Drawing number: 6 of 7

Project: CHESTERTON H.S. SWIMMING POOL

CHESTERTON, INDIANA

Extruded Polystyrene Insulation
FOAMULAR®

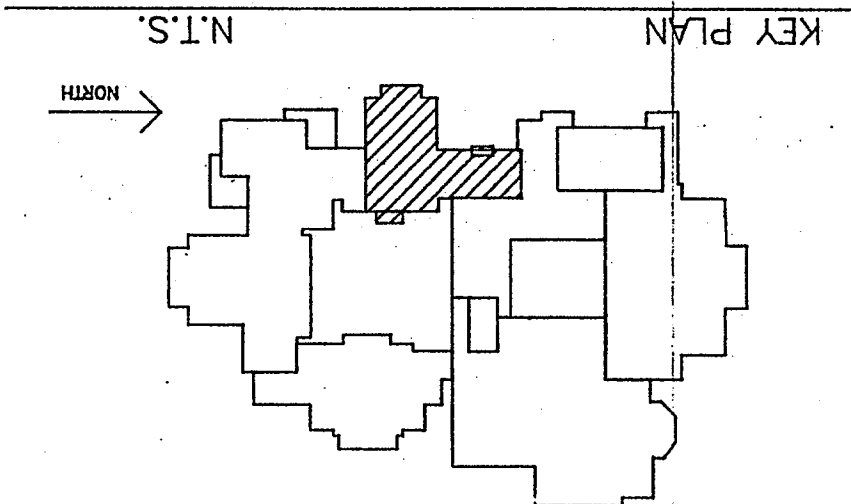
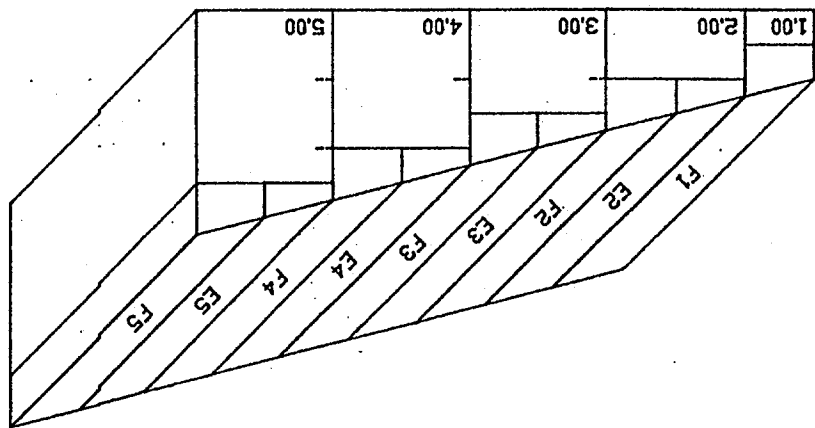
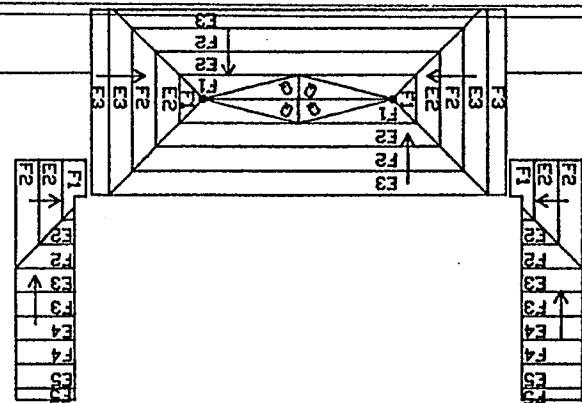
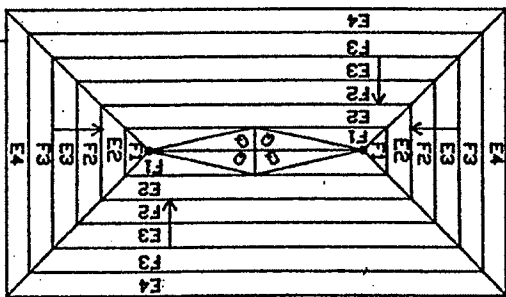
1. REVISED DRAWING FOR RELOCATION OF ROOF DRAINS PER W. R. KELSO.
2. CHANGED TAPER LAYOUT, SADDLE SLOPE AND THICKNESS PER FANNING & HOWEY 2/6/98
3. ADDED ROOF AREAS CHANGE SLOPES 4/14/98
4. CHANGED SLOPES IN VARIOUS ROOF AREAS AND MOVED DRAINS. 5/14/98
